Planning & Zoning Board Meeting

November 17, 2022 at 6:00 PM
Howey-in-the-Hills Town Hall
101 N. Palm Ave.,
Howey-in-the-Hills, FL 34737

TO: Town of Howey-in-the-Hills Planning Board
CC: J. Brock, Town Clerk
FROM: Thomas Harowski, AICP, Planning Consultant
SUBJECT: Venezia Townhouse Design Approval
DATE: November 3, 2022

TO: Howey-in-the-Hills Planning Board
CC: J. Brock, Town Clerk
FROM: Thomas Harowski, AICP
SUBJECT: 107 E. Croton Way Design Review
DATE: November 11, 2022

LEFT SIDE ELEVATION
SCALE 1/4" = 1'-0"

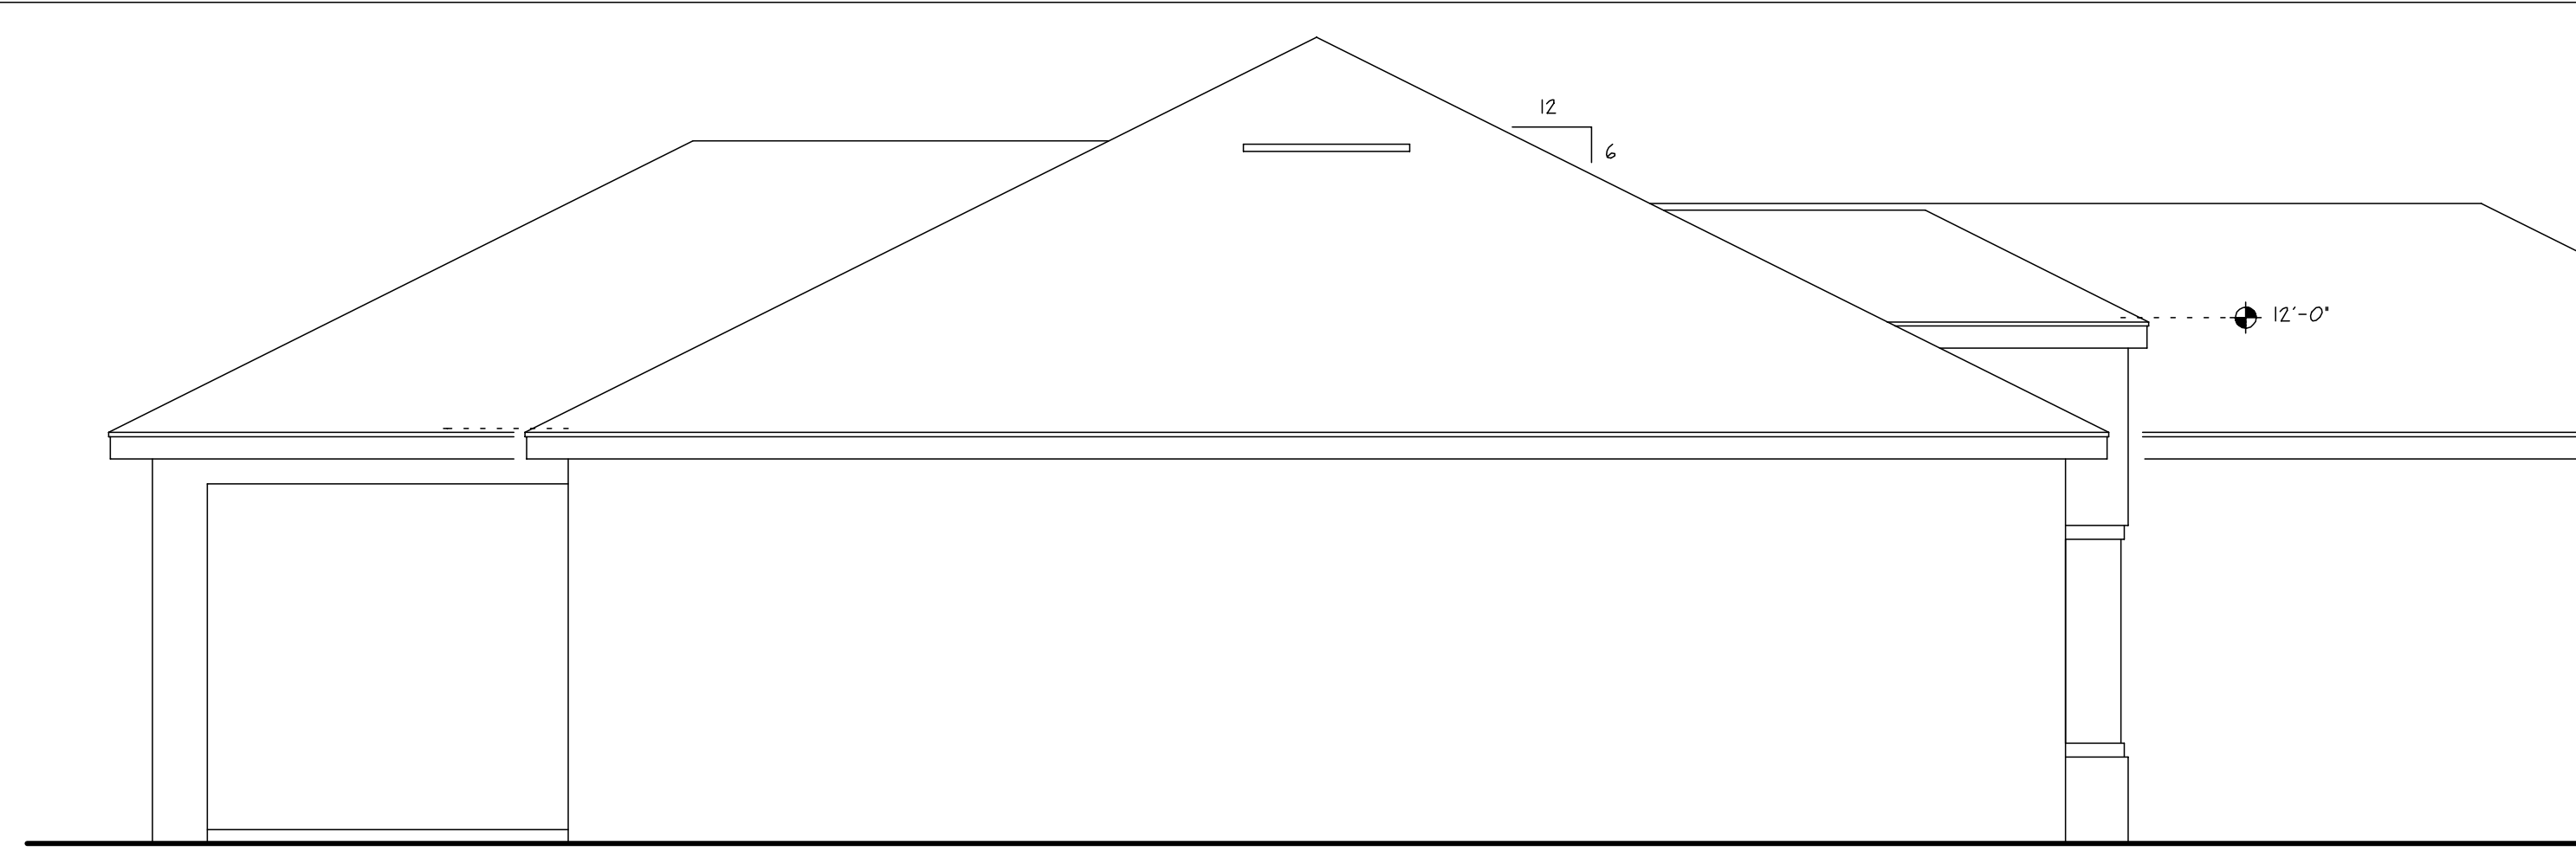
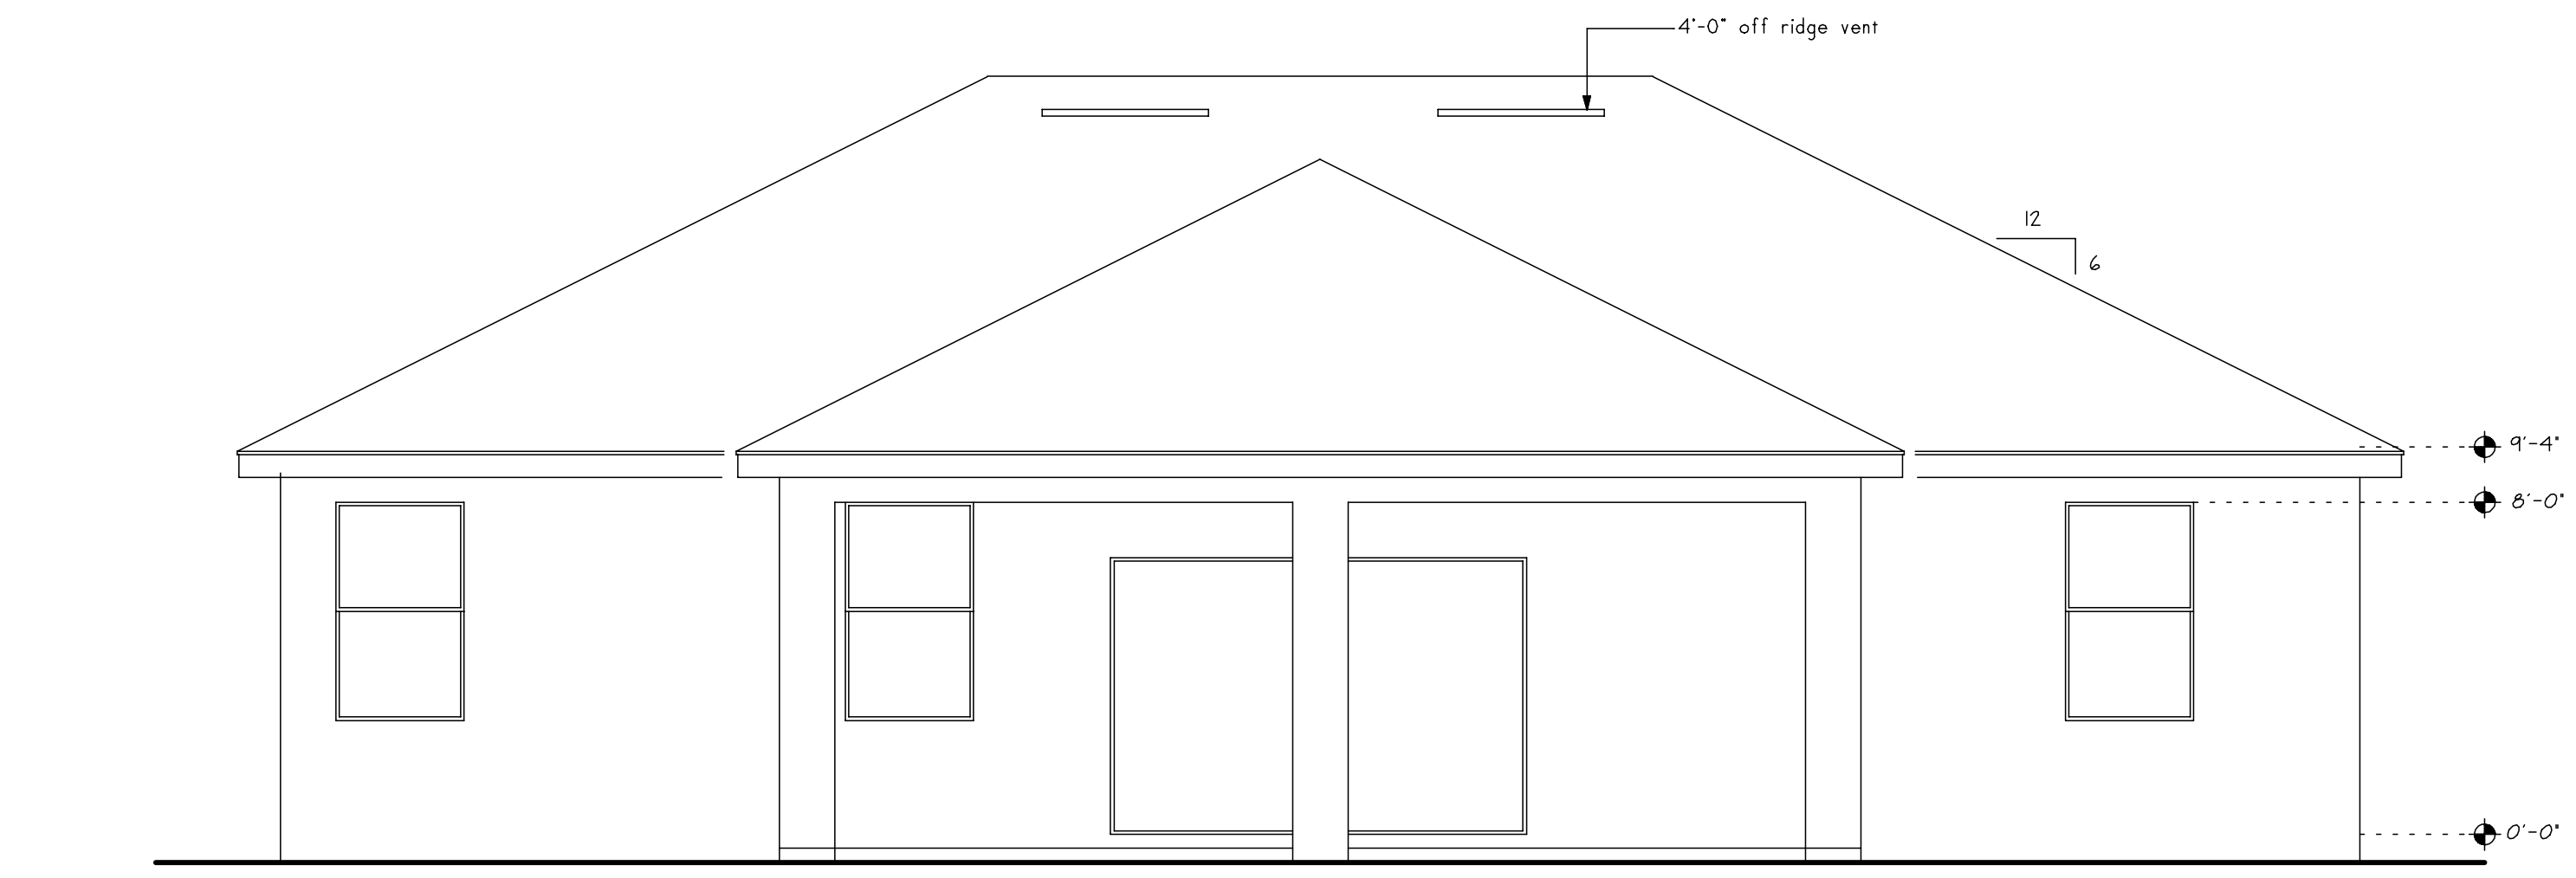
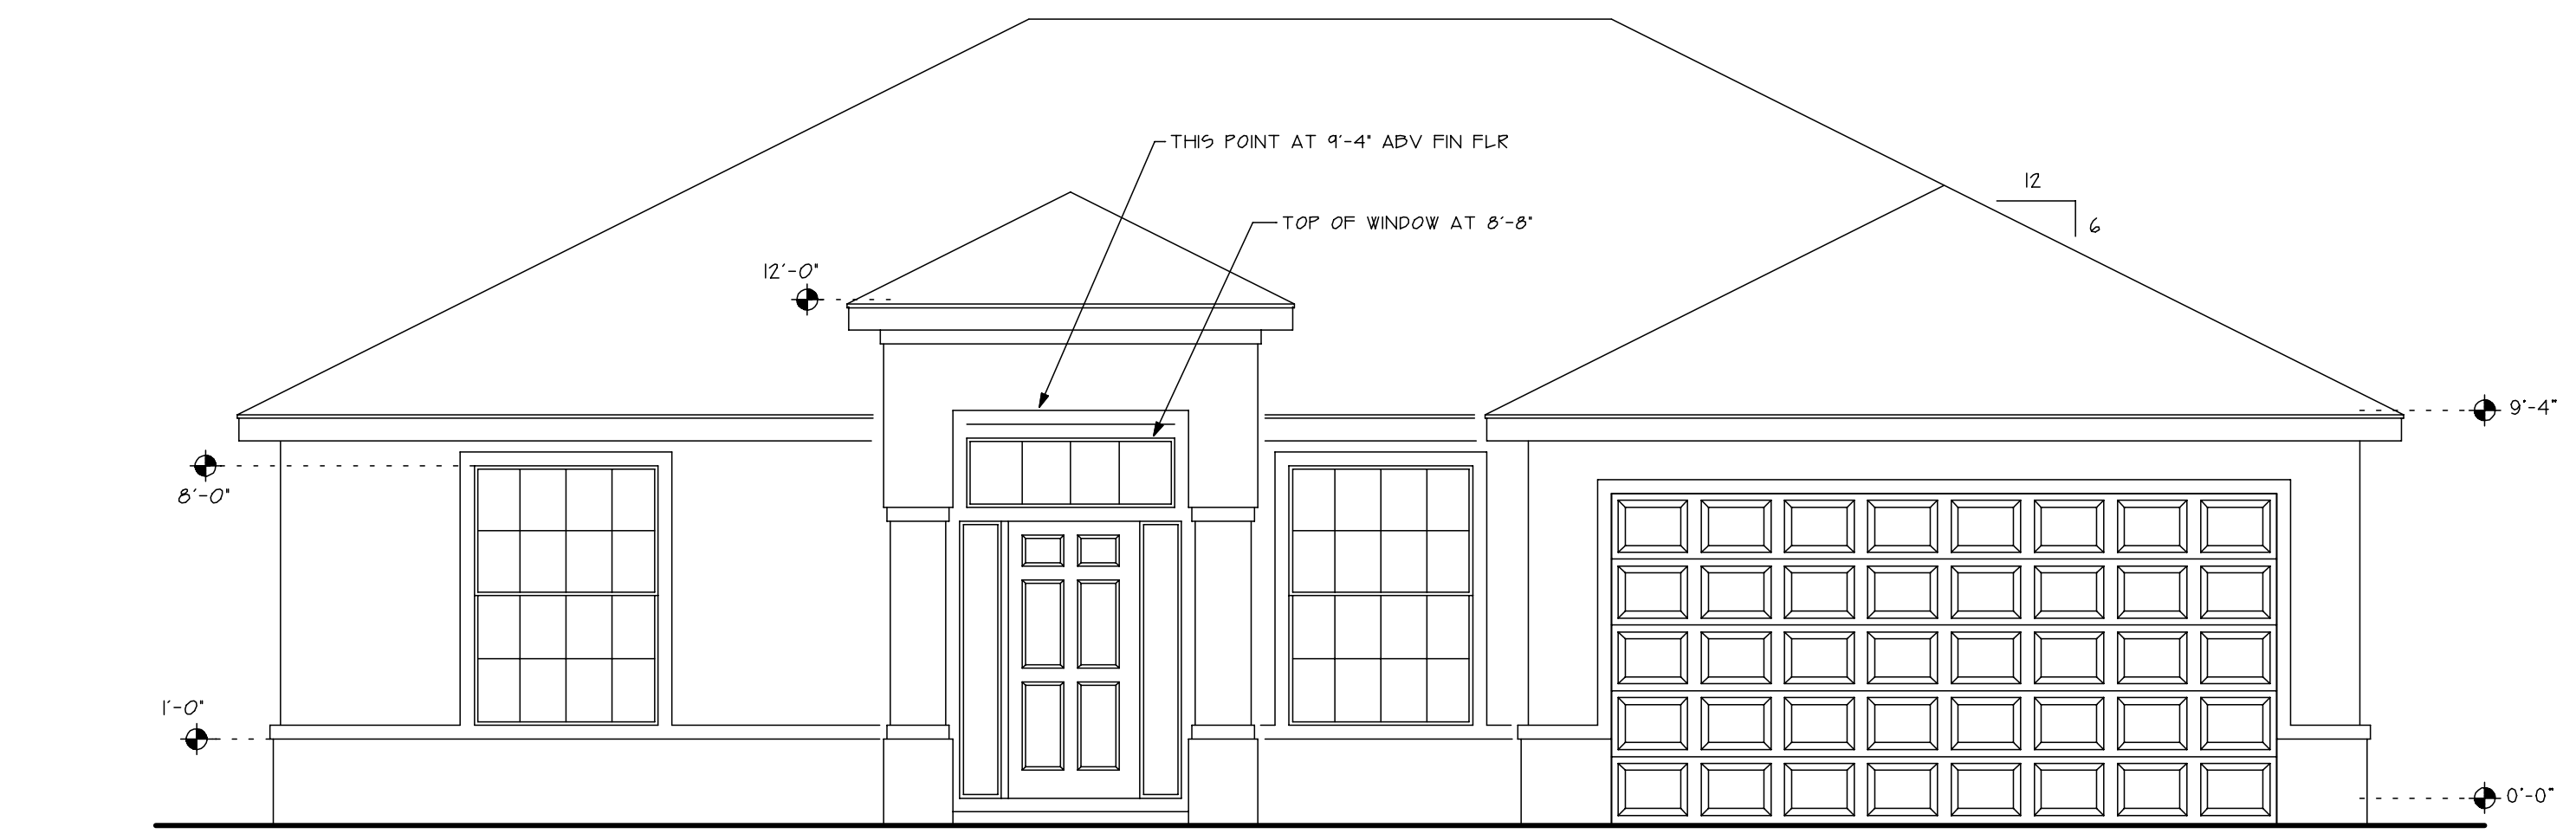
The plans for the proposed residence at 1101 North Temple Avenue have been reviewed for compliance with the code requirements and the results are as follows:

1. The roof design uses an approved material and includes a variation in the roof line as required.
2. The design calls for stucco exterior walls which meet the wall material requirements.
3. The design includes four design elements for the front (primary) façade.
4. The design includes two architectural design elements for the secondary facades.
5. The plans do not specify the color palette, so the applicant needs to confirm that at least two colors are proposed.
6. The proposed design meets zoning requirements for building area, building height, required garage area, and minimum floor area.
7. The lot meets the minimum requirements for MDR-1

Based on these findings, staff is recommending approval for zoning and design compliance conditioned on the applicant confirming the painting choices. The building official will review the plans for building code compliance.
